ADDENDUM NO. 1

Pleasanton Public Schools
Project City and State
TCEP No.: 796-001-12

Addendum #01, Bid Package #002R
Supplemental Drawing: SDS-001
Revision of Sheet: S3.02
Date: 10/18/13

2 SECTION DETAIL

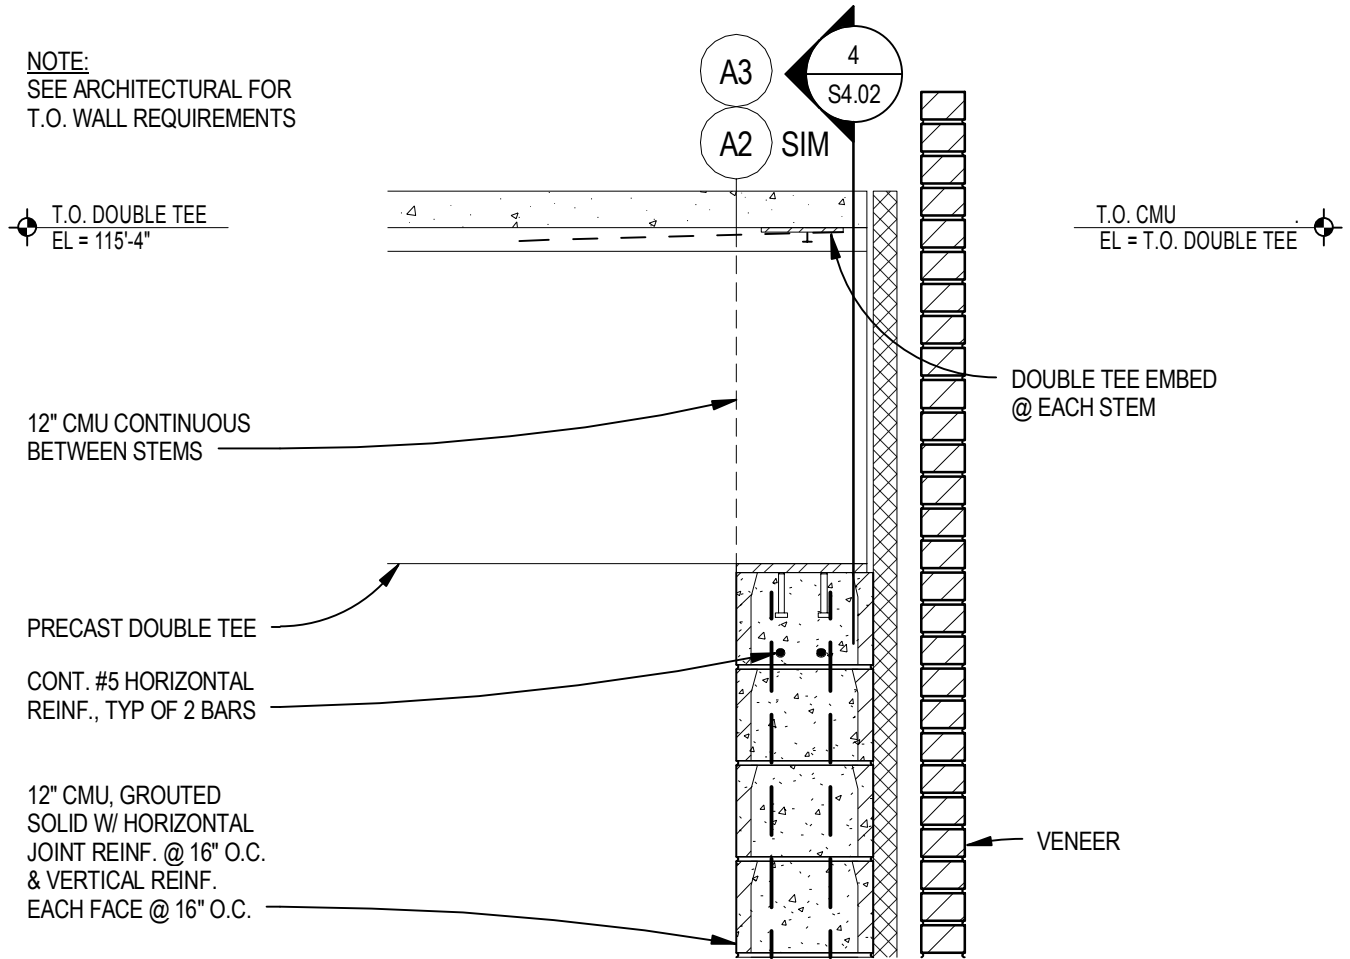
- Reference Section Detail 2. Replace this detail with the one shown on the attached Supplemental Drawing SDS-002.
- Add Section Detail 4/S4.02 included in this addendum on Supplemental Drawing SDS-003.
- Reference Section Detail 11. Delete this detail.
- Reference Section Detail 12. Delete this detail.
- Reference Detail 14, Double Tee Schematic. Revise top of stem extension to eliminate chamfered portion of stem. Top of stem extension may be rectangular in shape.
